**Re: Supplemental Remedial Investigation Work Plan
3083 Webster Ave BCP Site
3083 Webster Avenue, Bronx, NY 10467
Block 3331; Lot 57
NYSDEC BCP Site Number: C203184**

Hydro Tech Environmental Engineering and Geology, DPC (HTE) hereby submits a supplemental Remedial Investigation Work Plan (Supp RIWP) for above-referenced New York State Department of Environmental Conservation (NYSDEC) Brownfield Cleanup Program (BCP) Site No. C203184 (Site) on behalf of 6014 BCD Realty, LLC (the "BCP Applicant"). This Supp RIWP addresses Comment #2 in NYSDEC correspondence dated October 29, following the review of the draft Remedial Investigation report prepared by HydroTech and dated September 2025. This Comment #2 is related to groundwater data gaps associated with insufficient characterization of bedrock hydraulic gradient and permeability to fully understand the site-wide fate and transport of chlorinated VOCs (CVOCs) identified during the RI in MW-2a. The scope this Supp RIWP consists of installing three bedrock monitoring wells screened in bedrock, only, and the performance of a downhole hydro-geophysical survey in these wells to determine the extent of vertical and horizontal migration of

FIGURE 3: PROPOSED LOCATIONS OF
BEDROCK MONITORING WELLS

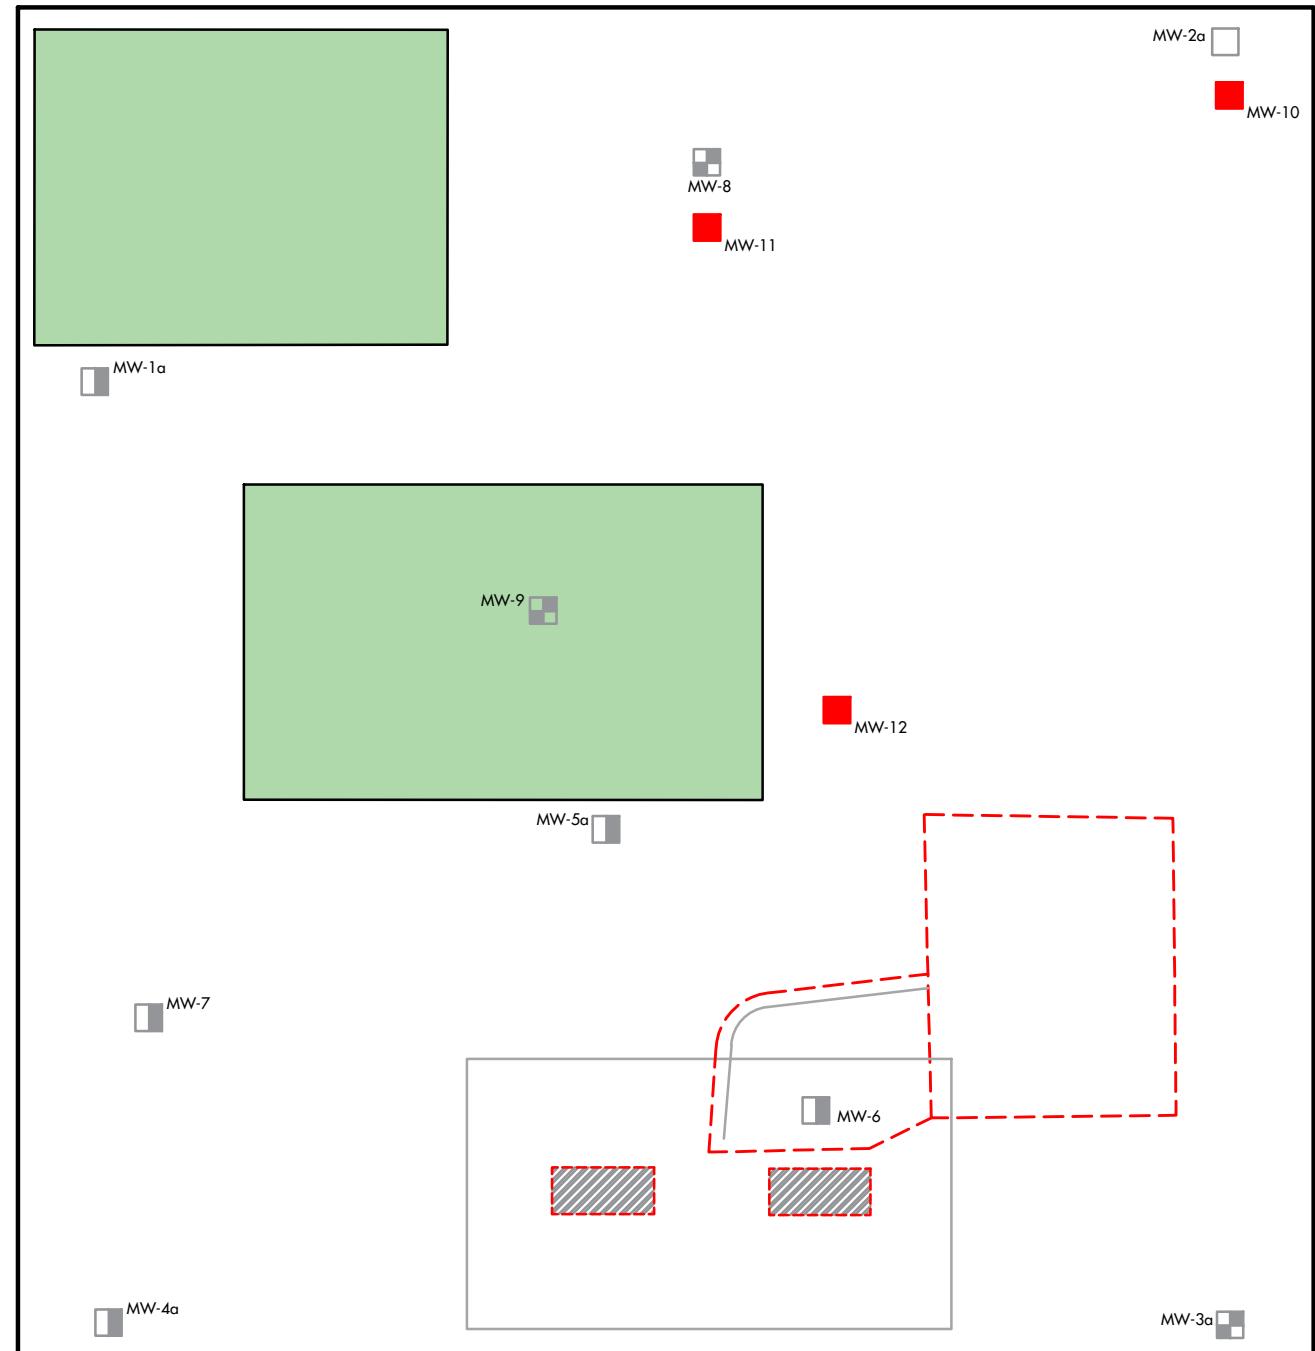
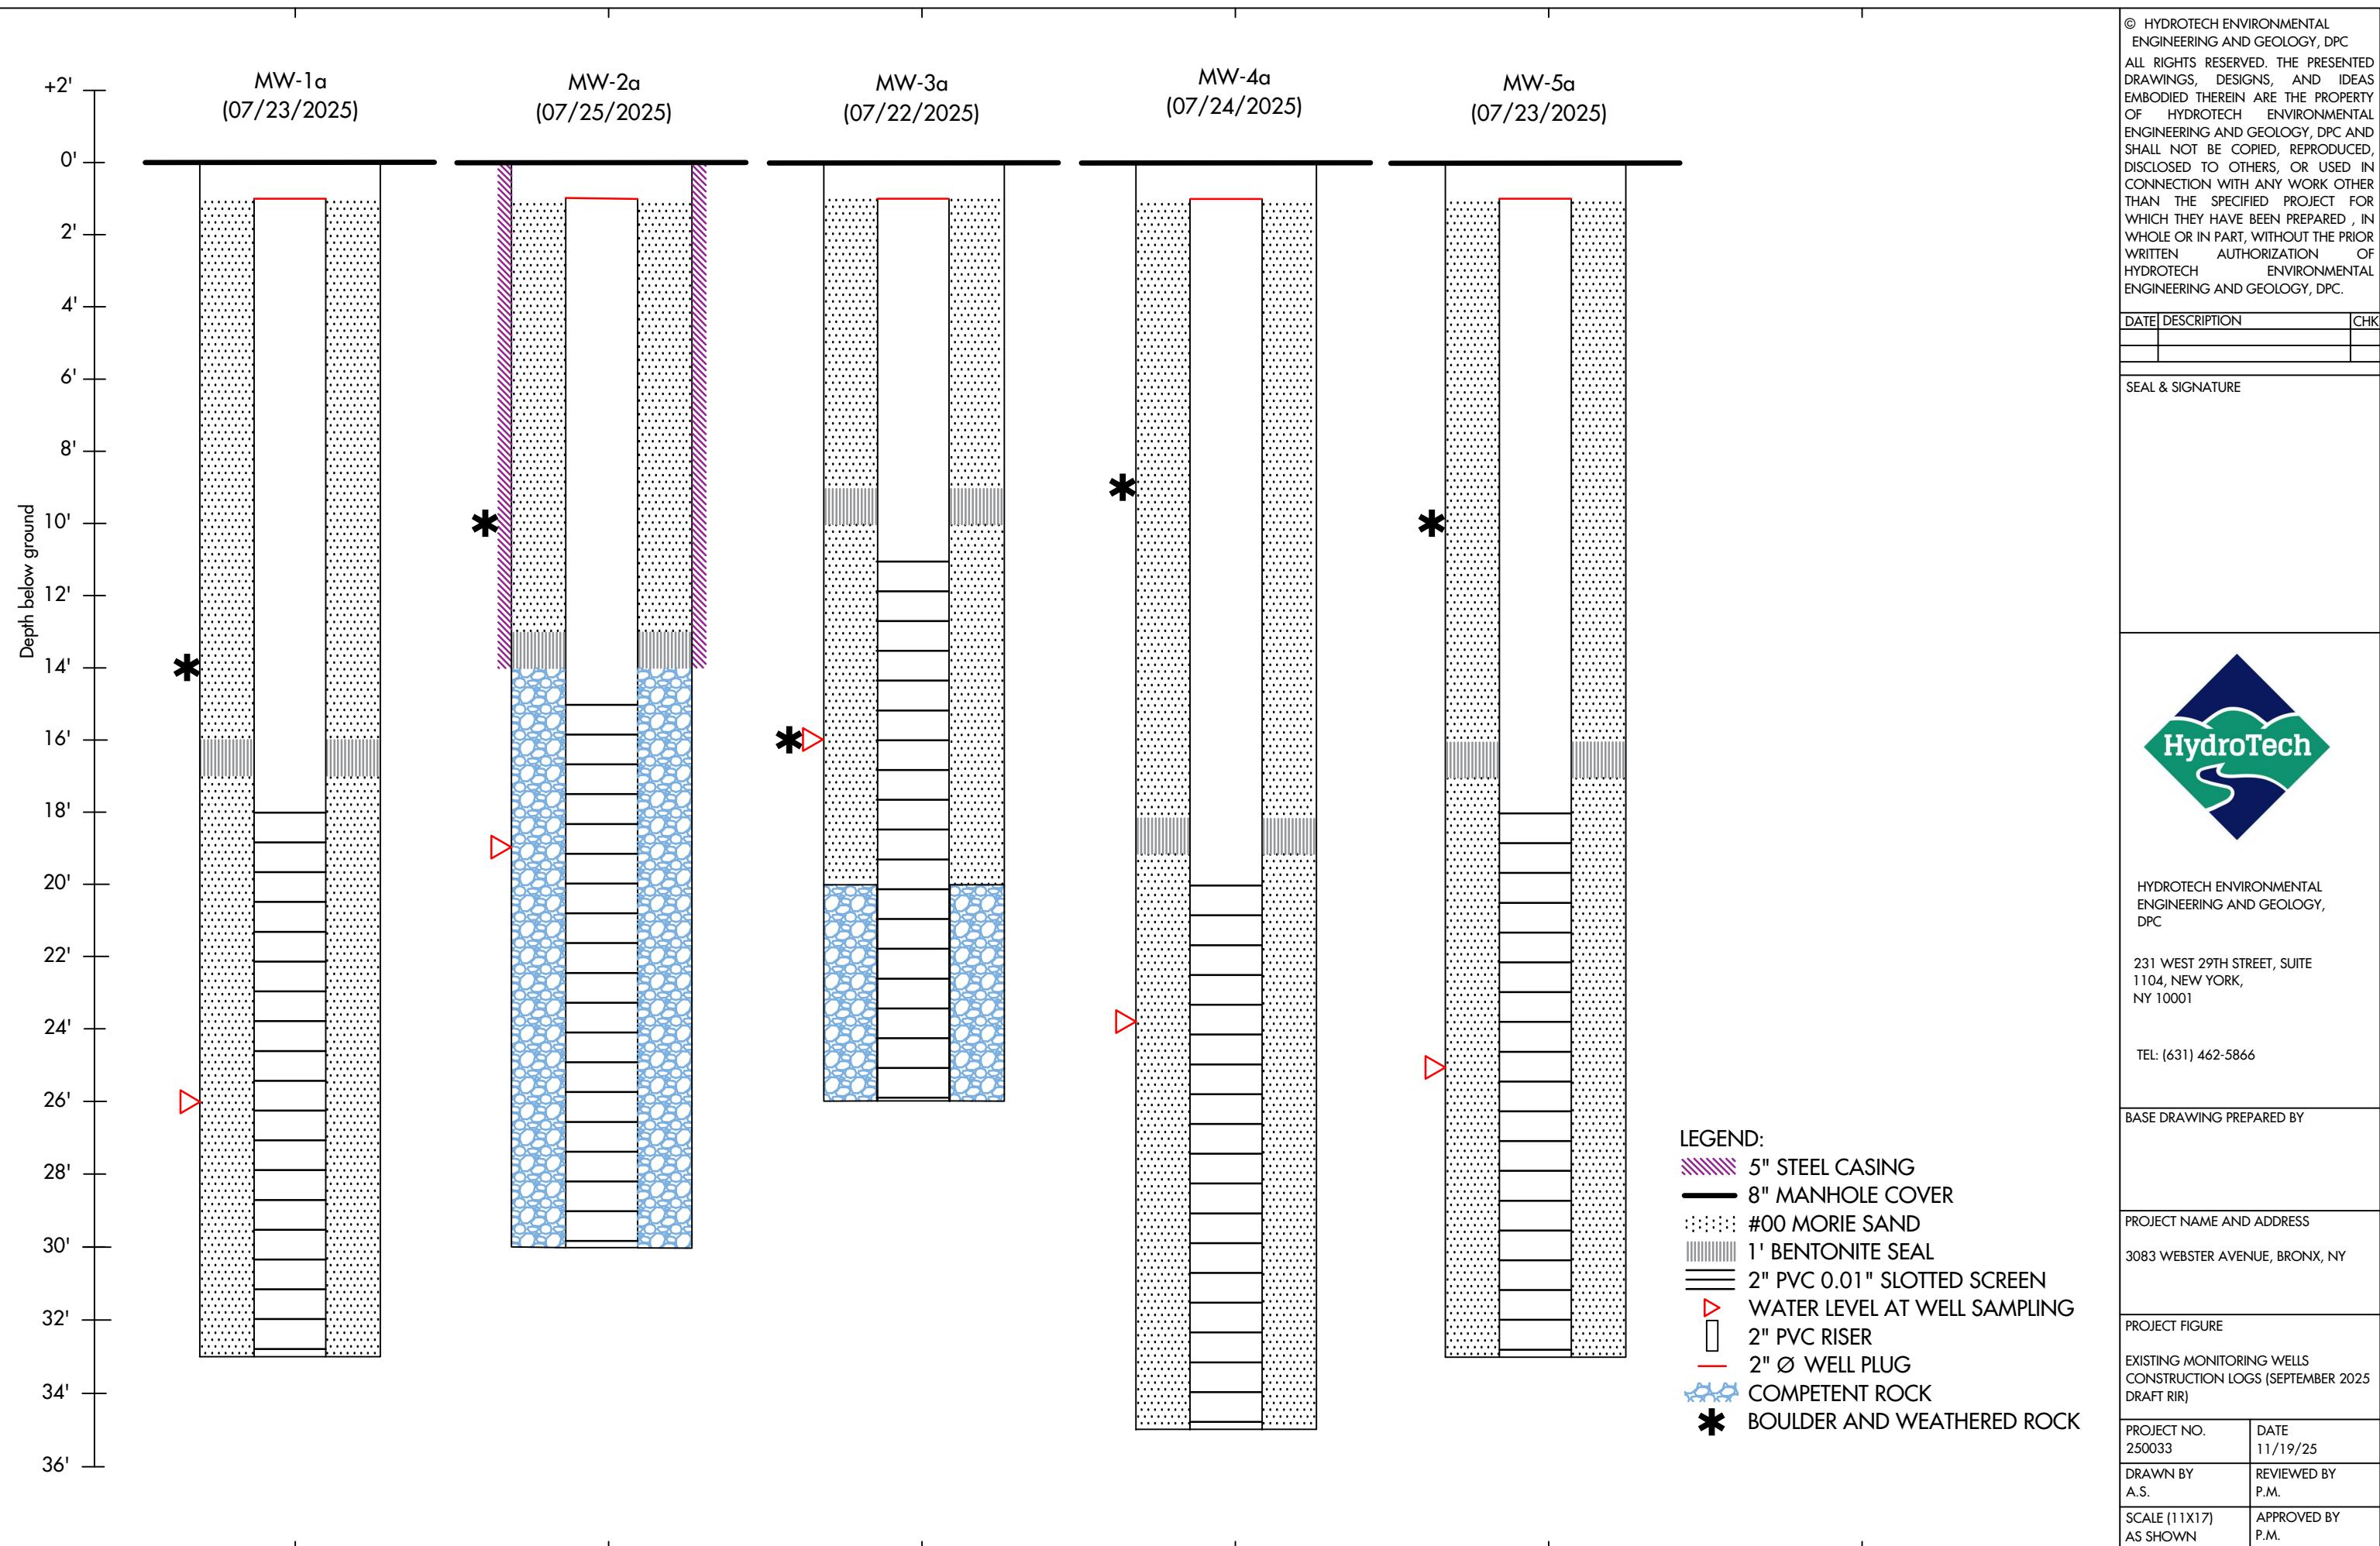
- 2) General Comment: Pursuant to Comment #1(c) above, NYSDEC requests that additional wells are installed on the Site to collect additional hydrogeological data at the Site. Please prepare a Supplemental RI Work Plan which includes the following:

- a) Installation of two additional monitoring wells screened in bedrock, only, using procedures outlined in the NYSDEC-approved RIWP Addendum dated July 18, 2025. Bedrock monitoring wells should be spaced adequately to determine extent of chlorinated VOC impacts identified in MW-2a.

Per NYSDEC Comment #2 in the October 2025 correspondence, downhole geophysical logging data shall be collected in two additional monitoring wells to be screened in bedrock and in any open borehole screened monitoring wells extending into bedrock. After consulting with a geophysical specialty firm, Hager-Richter Geoscience, dba HR Geological Services in New York (HRGS), the downhole geophysical logging will be performed with high efficiency in open bedrock borehole with a casing driven at least 5 feet into bedrock and in exposed bedrock column with a minimum length of 10 ft. Based on this bedrock survey criteria and the variation of the depth to bedrock beneath the Site as determined during the previous RI fieldwork, HydroTech proposes to install three bedrock monitoring wells designated as MW-10, MW-11 and MW-12. These three new

monitoring wells will be spaced adequately and screened in bedrock, only. Specifically, MW-10 will be installed in the vicinity of existing well MW-2a, MW-11 will be installed in the vicinity of existing well MW-8 and MW-12 will be installed in the space between existing wells MW-3a and MW-9. Per HRGS recommendations, the new monitoring wells shall be offset by at least 5-7 feet from existing ones. A map showing the locations of proposed bedrock monitoring wells is shown in **Figure 3**.
